[1] REDLINE REVISION 6/30/03

MARYLAND DOT - STATE HIGHWAY ADMINISTRATION
Office of Traffic & Safety
TRAFFIC ENGINEERING DESIGN DIVISION

MD 122 AND LORD BALTIMORE DR.

DRAWN BY:	ANGELUS BULLOCK	F.A.P. NO.	03012200.15	TS NO. 4027E	SHEET NO.
CHECKED BY:	EMM / RRZ	S.H.A. NO.			
SCALE:	3-10-2000	COUNTY:	BALTIMORE	T.I.M.S. NO. E545	12 OF 23
DATE:	1"=20'	LOG MILE:	XX1005885

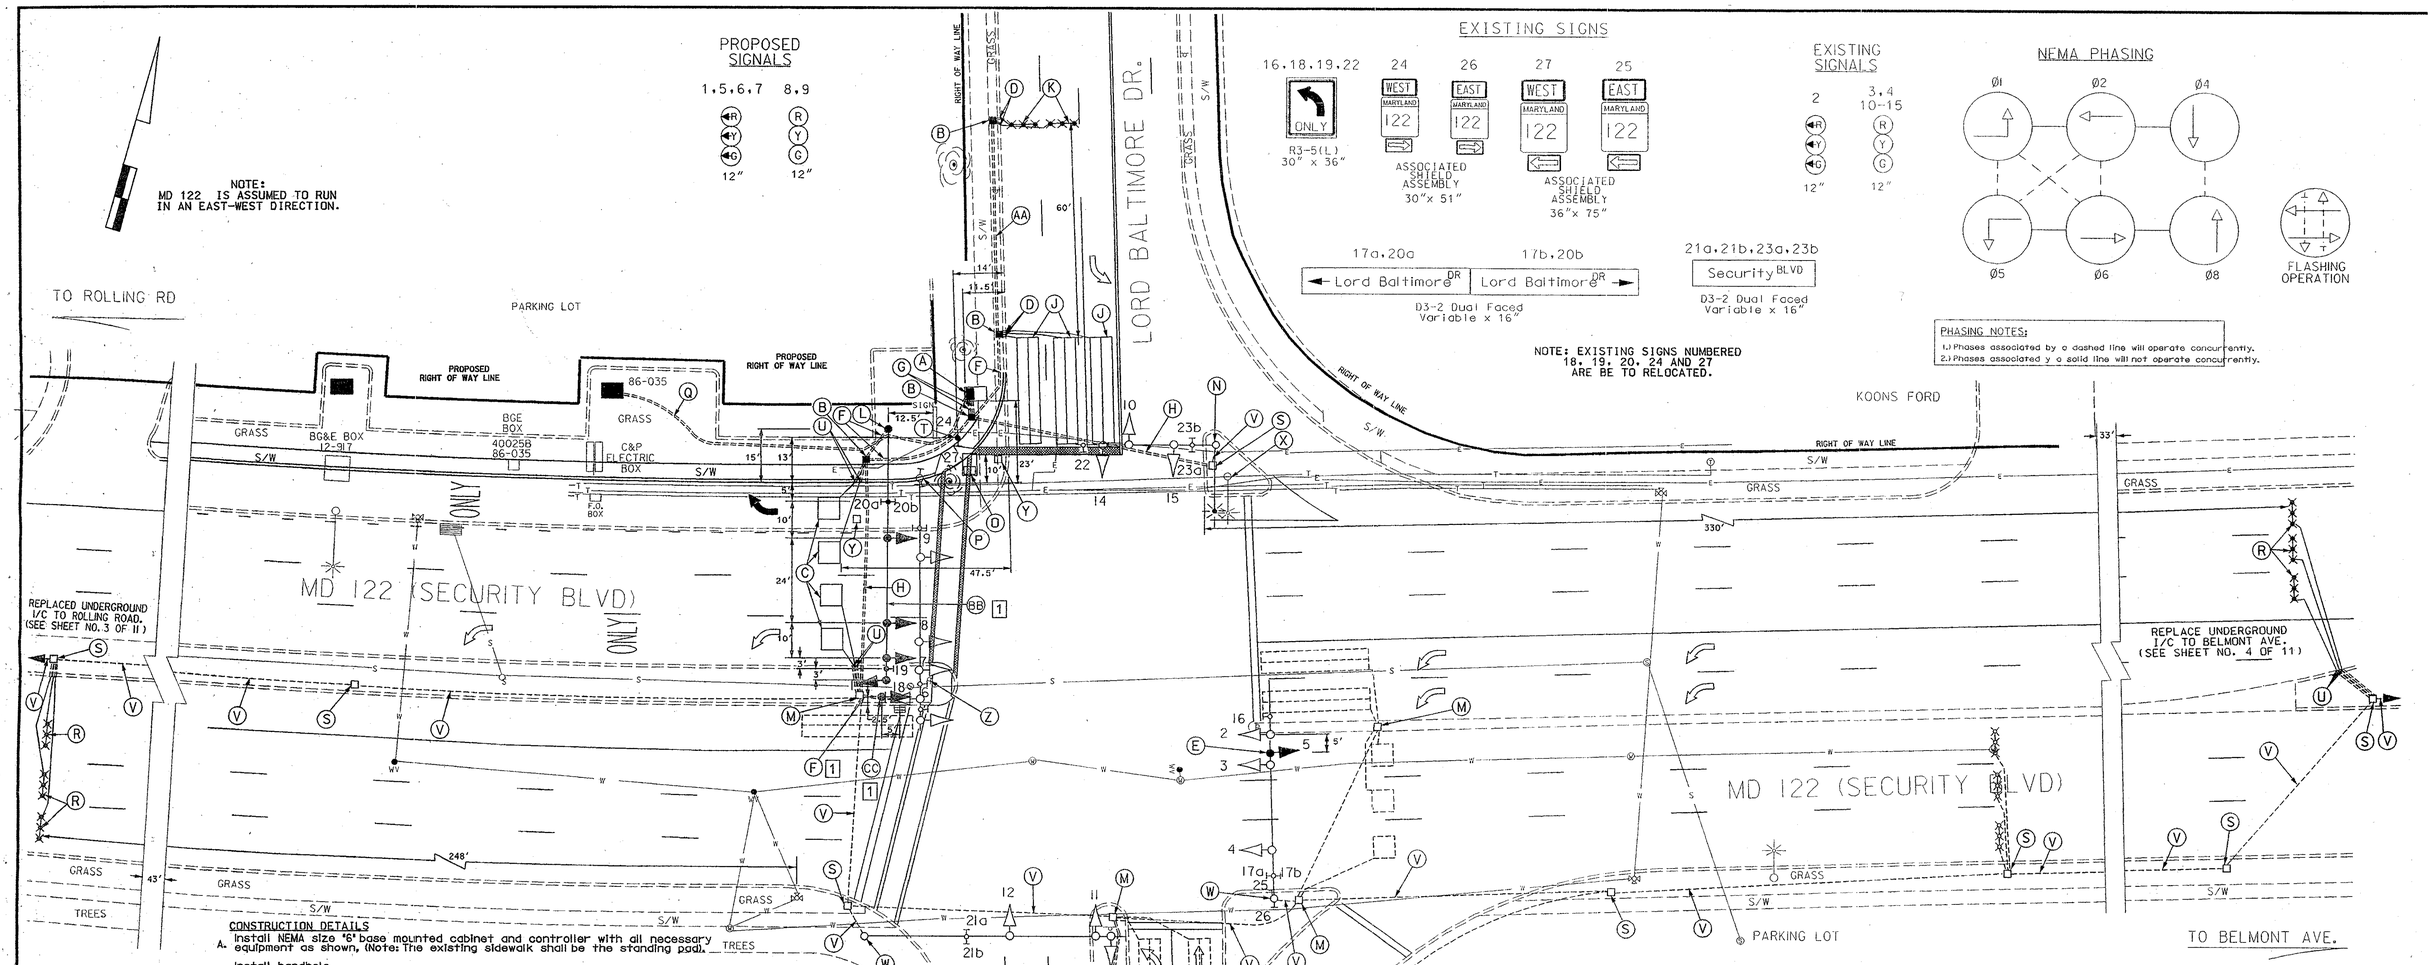
[1] BB. Relocate signal heads and signs on mast arm as dimensioned.
[1] CC. Install 10' pedestal pole with signal head and R3-5 sign mounted on the pedestal pole. (Note: 1-3" 90° PVC bend)
